SERVICE BULLETIN

OIL — OIL COOLER, AIR COOLED — REPLACE WITH A MORE DURABLE OIL COOLER

V2500 Series 79-0109

V2500-ENG-79-0109

LOCATION OF THE AIR COOLED OIL COOLER
79-21-42
FIGURE 1

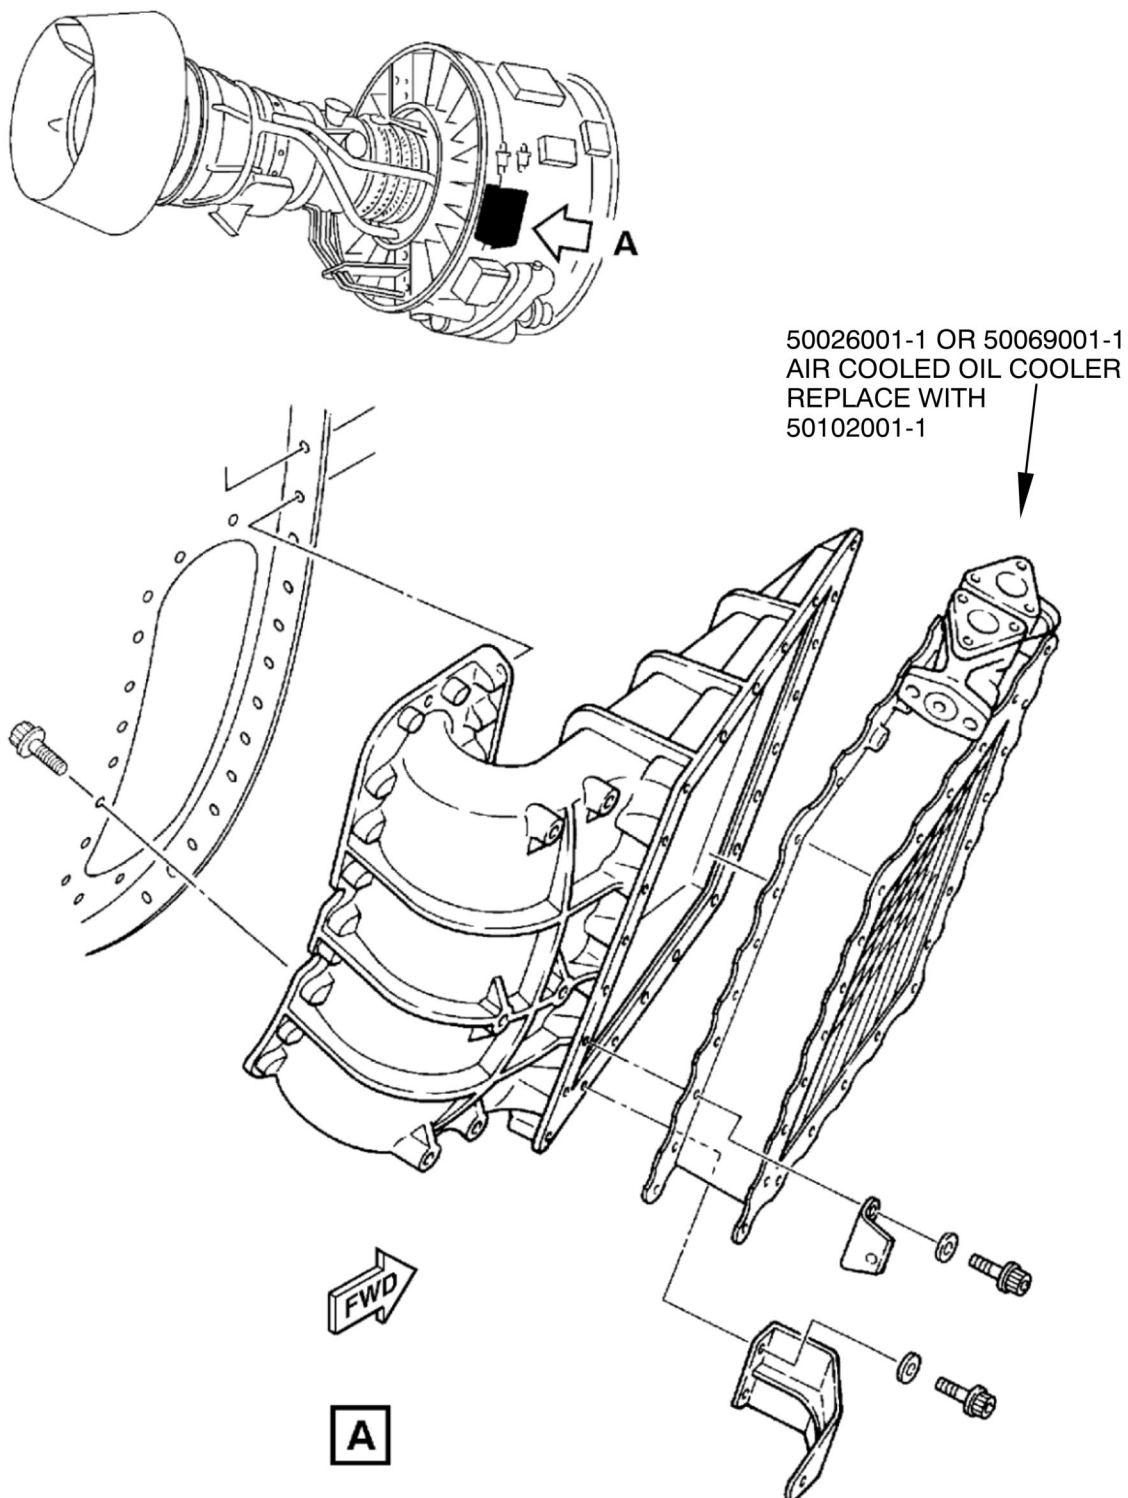
1. Replace the ACOC, PN 50026001-1 or PN 50069001-1 with PN 50102001-1 refer to Reference 7, AMM, Chapter/Section 70-00-32. See Figure 1.
2. Recording Instructions
 - A. A record of accomplishment is required.

1. Replace the ACOC, PN 50026001-1 or PN 50069001-1 with PN 50102001-1 refer to Reference 6, EM, Chapter/Section 70-00-32. See Figure 1.
2. Recording Instructions
 - A. A record of accomplishment is required.

Parts Progression To Show the Changed Part in Relation to Other Parts

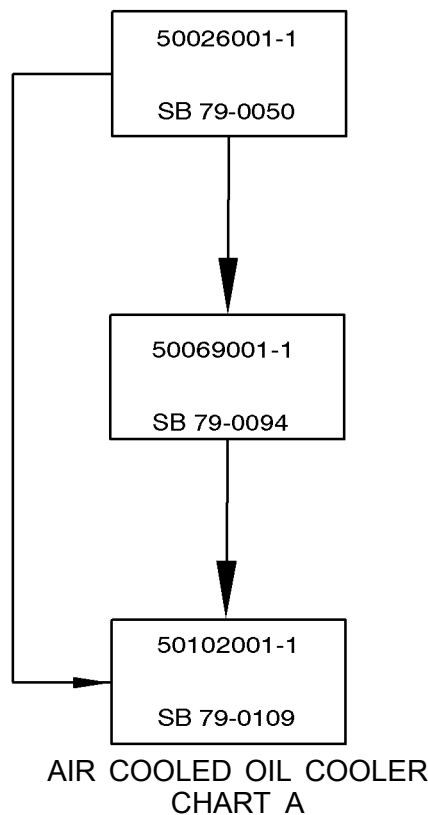
ACOC Part Numbers Progression		Exchange Unit Price 2017 (\$)
From	To	
50069001-1 SB 79-0094	50102001-1 SB 79-0109	7,200
50026001-1 SB 79-0050	50102001-1 SB 79-0109	7,200
Previously Upgraded		
50069001-1* SB 79-0094	50102001-1 SB 79-0109	3,500
